METROPOLITAN GOVERNMENT OF NASHVILLE AND DAVIDSON COUNTY

Metropolitan Historic Zoning Commission
Sunnyside in Sevier Park
3000 Granny White Pike
Nashville, Tennessee 37204
Telephone: (615) 862-7970
Fax: (615) 862-7974

STAFF RECOMMENDATION
1618 17th Avenue South
August 19, 2015

Application: New construction – addition
District: South Music Row Neighborhood Conservation Zoning Overlay
Council District: 19
Map and Parcel Number: 10408031000
Applicant: John Root, Architect
Project Lead: Sean Alexander, sean.alexander@nashville.gov

ARCHITECTURAL SITE PLAN

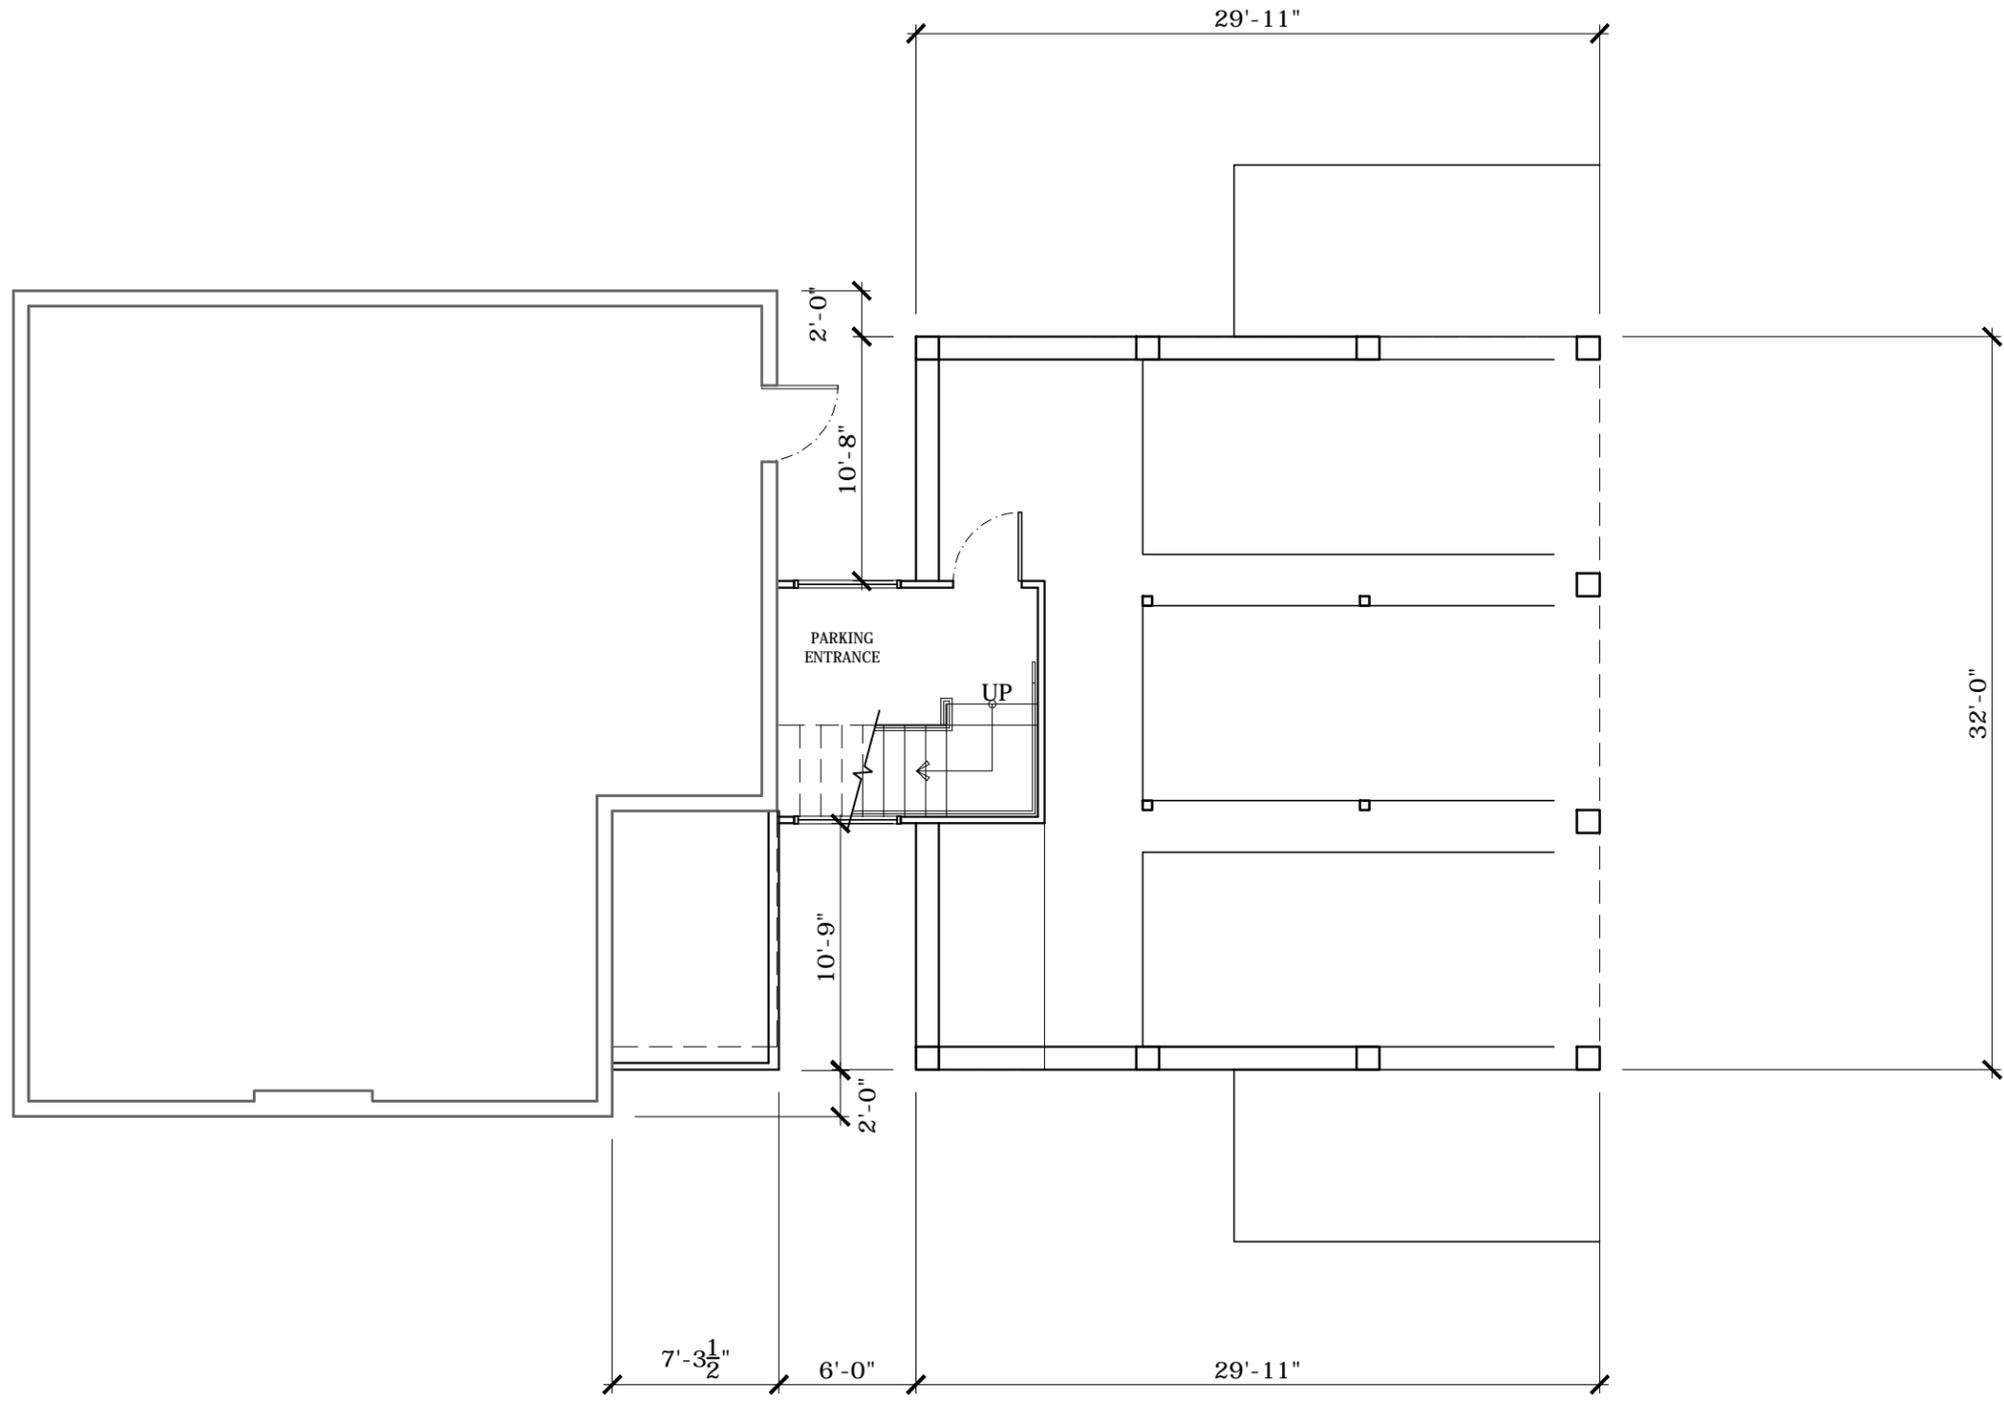
Location & Removability: The addition will be at the rear of the building, squaring off the back wall which is partially extended by an existing rear projection on the left. The new addition will sit in two feet (2') from the right side of the building and extending back seven feet (7') to match the depth of the existing left wall. From there the addition will continue by stepping in twelve feet, eight inches (12'-8") on the left side and by ten feet, nine inches (10'-9") on the right. After an eleven foot (11') wide hyphen extends back six feet (6'), the addition will step back out to two feet (2') in from the sides of the original building on both sides.

Setback & Rhythm of Spacing: Because the sides of the addition will sit in from the original building, it will have greater side setbacks. At eight feet (8') on the left and ten feet (10') on the right, and the rear setback will be thirty-eight feet (38'). Staff finds the setbacks to meet the bulk zoning requirements and to meet section II.B.1.a of the design guidelines.

PARKING LEVEL PLAN

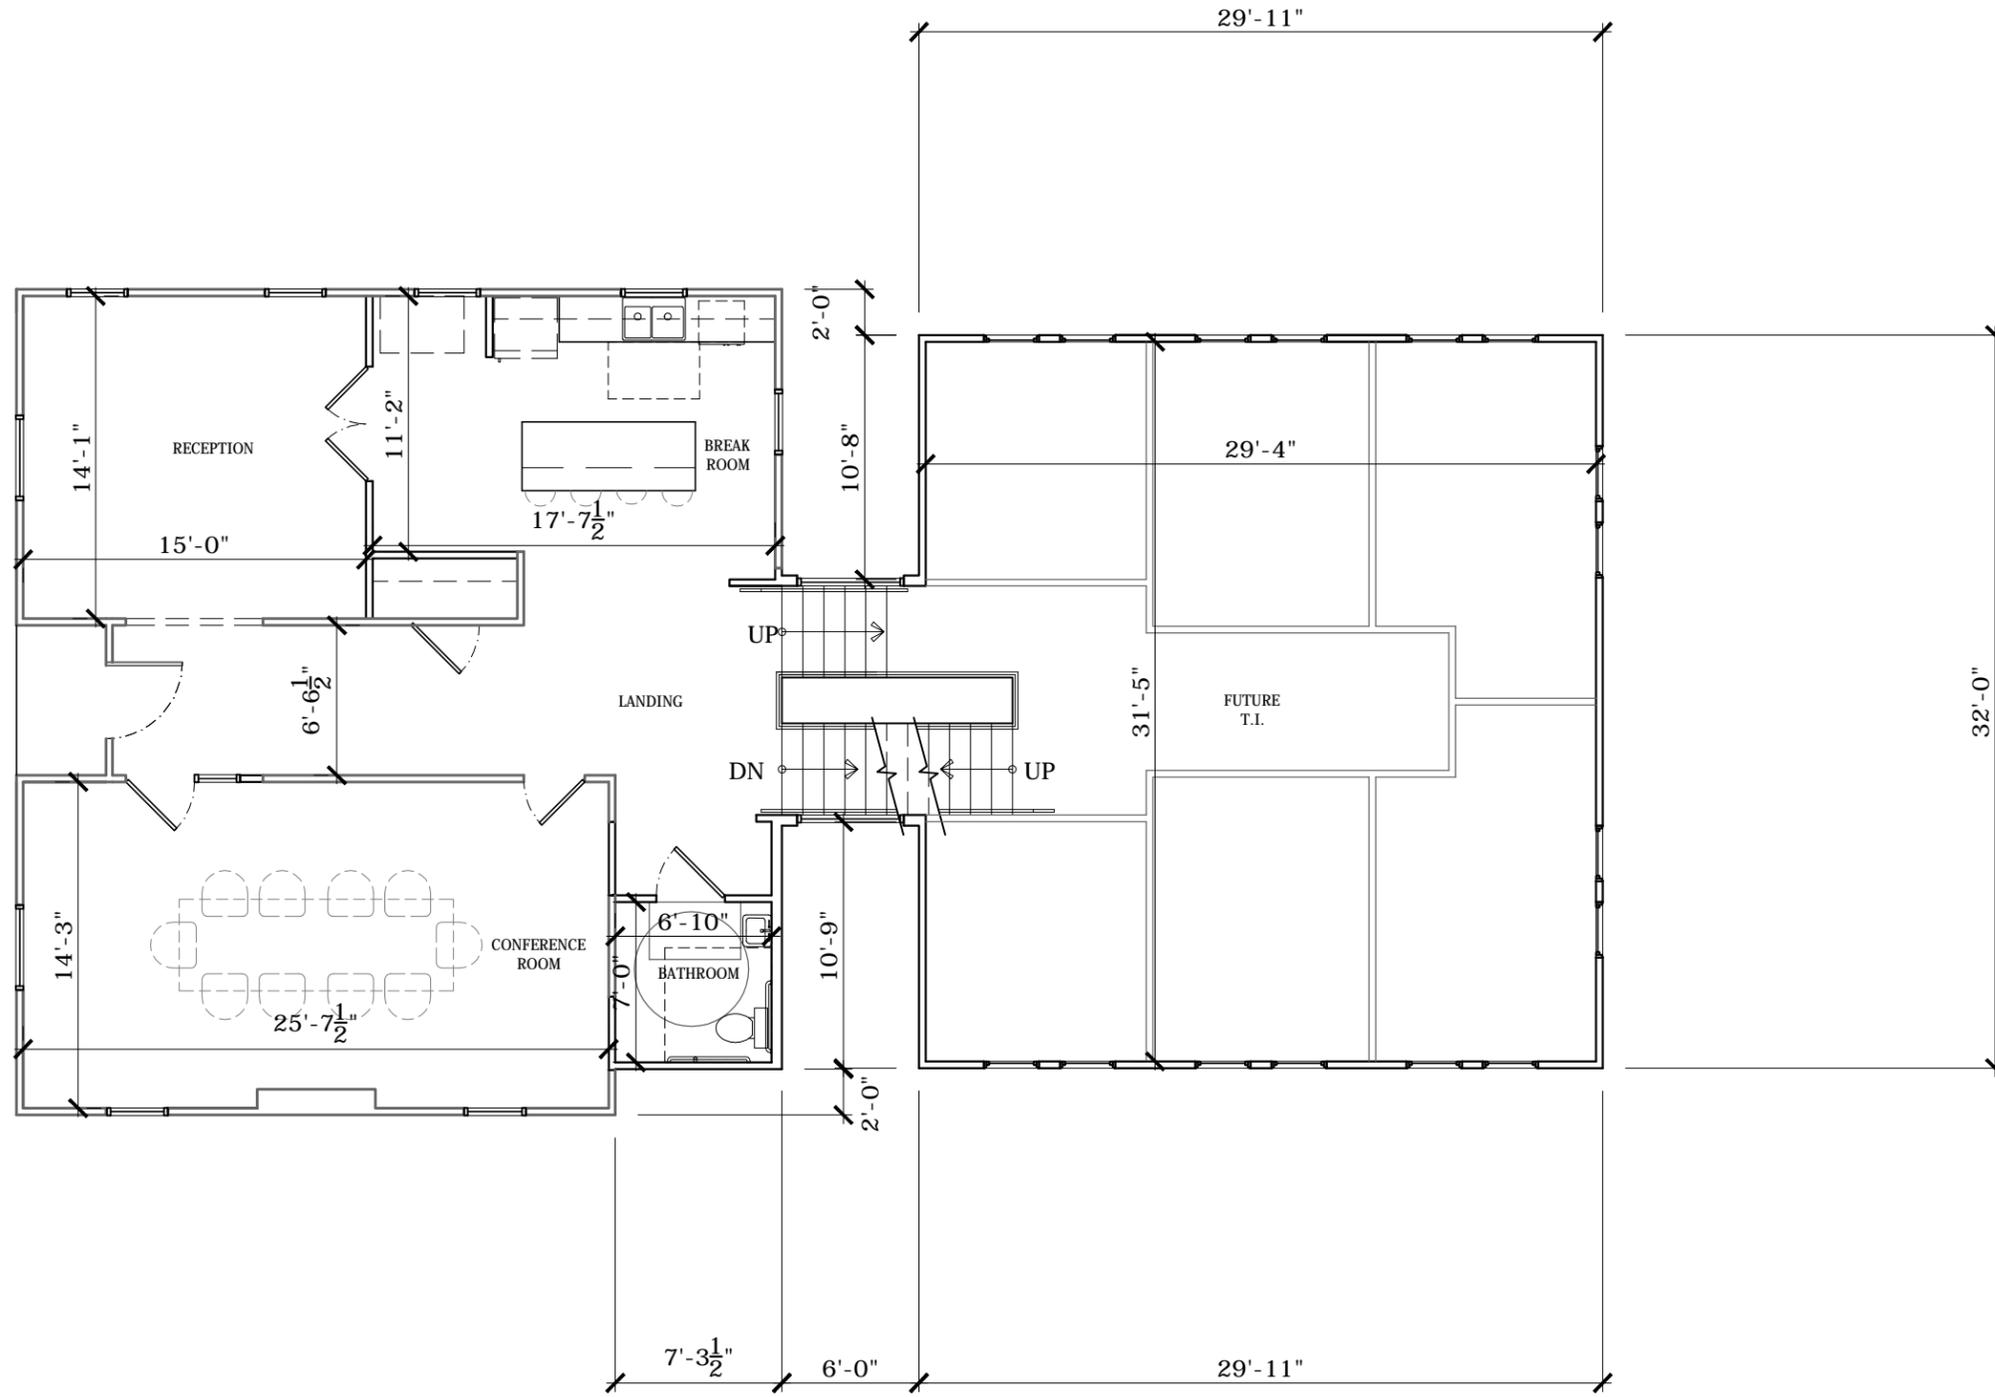
grade at the rear to create a third story, partially below the existing first-floor level. The basement-level will contain mechanical systems and parking with open arched bays.

Outbuildings: Although there is not a detached outbuilding proposed as there was in the 2013 application, this addition would include basement-level parking below the main floor level of the addition. Although attached garages are generally not appropriate, in locations where they are below street-grade, are accessed from the rear, and are in the location of other historic garages nearby, the Commission has found them to be appropriate.

The proposed basement level parking, however, does not meet those criteria as the lot at 1618 17th Avenue South is relatively flat. Basement level garages are not typical of the surrounding area, therefore staff finds that the project does not meet section II.B.2.h of the design guidelines.

Staff suggests resubmitting after removing one story from the addition in order to make the scale subordinate to the historic house, reducing the siding reveal to five inches (5"), and providing further information about the doors and windows.

1 17TH AVE. S ELEVATION

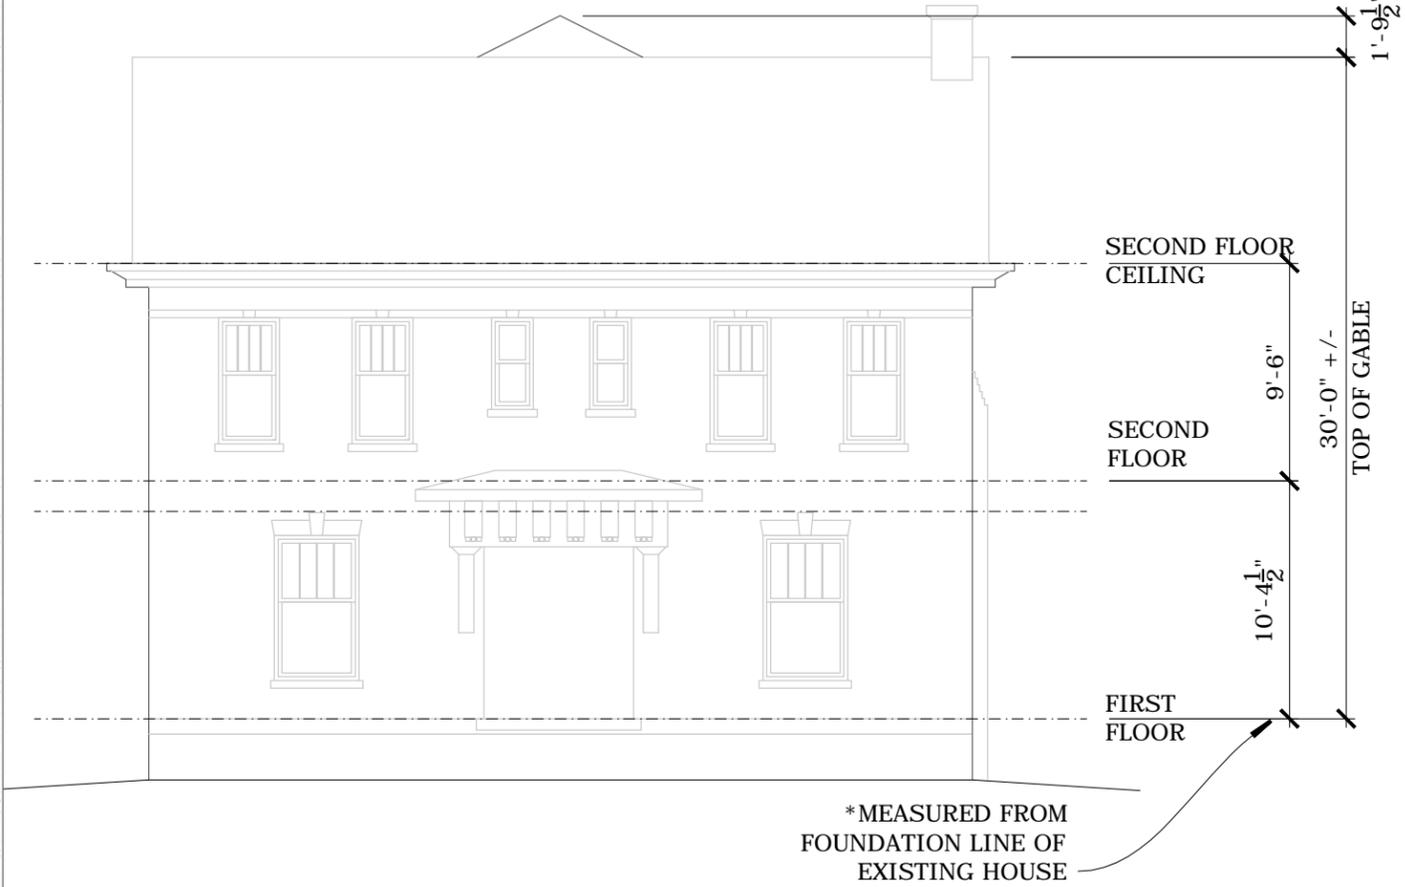
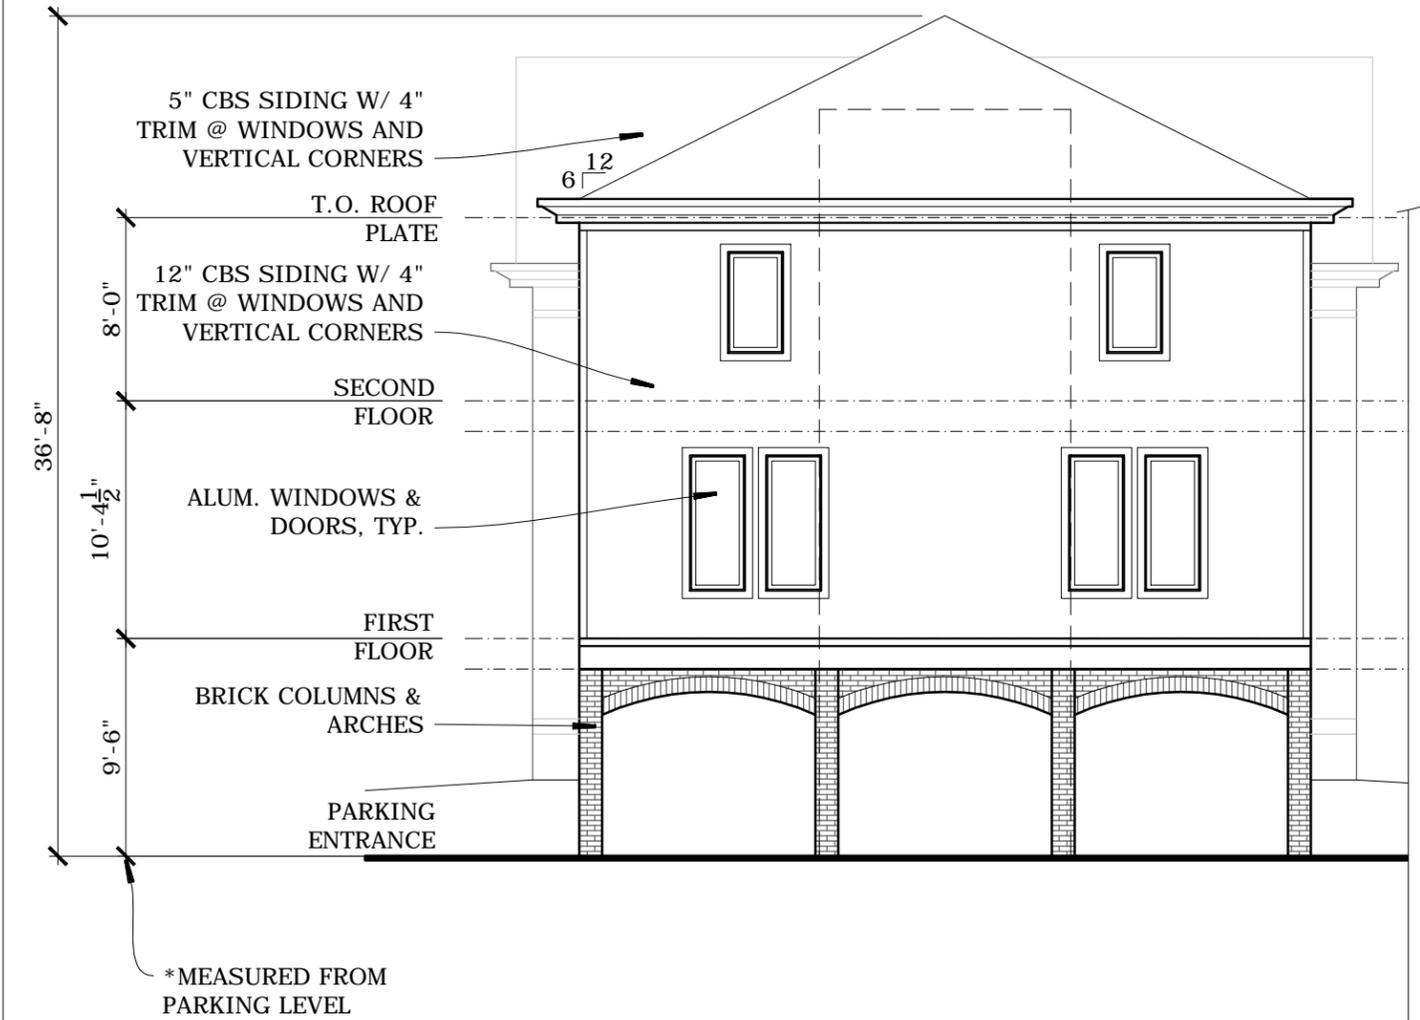
Height, Scale & Building Shape: The width of the primary two-story massing of the addition will be less than the existing structure by two feet (2') on both sides, with a narrower hyphen connecting it to the historic house. The roof of the addition will be twenty-two inches (22") above the existing roof ridge. The addition would excavate the

Although the roof peak is less than two feet (2') higher than the original roof, the eaves will be three feet (3') higher than the existing eaves and the foundation line will be three feet, six inches (3'-6") higher than that of the historic house. With these components higher than their historic counterparts, Staff finds that the addition will not be subordinate to the historic house.

While taller additions may be appropriate when the height is not perceptible from the right-of way, staff finds that the current proposal would be highly visible and will resemble a new three-story house behind the historic two-story house.

Design: The cornice and eave of the addition will match the original house, and the rhythm and proportion of openings is consistent with the existing window pattern. The addition will be twenty-two inches (22") taller than the existing building and while taller additions can sometimes be appropriate, Staff finds the scale of the proposed addition here is not subordinate to the historic house.

Materials: No changes to the historic house's materials were indicated on the drawings. The addition will primarily be clad in smooth face cement fiberboard with a reveal of twelve inches (12"). In general, the Commission has not approved clapboard siding with a reveal greater than five inches (5"), except as an accent material. In addition, the wider reveal increases the perceived massing. The trim will be cement fiberboard. The foundation will be brick and the roof will be architectural fiberglass shingles, matching the brick and roof of the existing building. The windows on the primary massing of the addition will be aluminum casements, with aluminum storefront-type windows in the narrow hyphen connector, and staff asks to approve the final window and selections prior to purchase and installation. With a condition that the reveal of the siding is no greater than five inches (5") and with staff's final approval of the windows, staff finds that the known materials of the project meet section II.B.1.g of the design guidelines.

Roof form: The roof of the primary massing of the addition will be hipped with a 6:12 pitch on the side slopes and 10:12 on the front and rear. The original side-facing gable roof has a pitch of 9:12. Although not matching the original roof, the new roof form is similar enough that it would not contrast greatly and impact the character of the original building. Staff finds that the project would meet section II.B.1.d of the design guidelines.
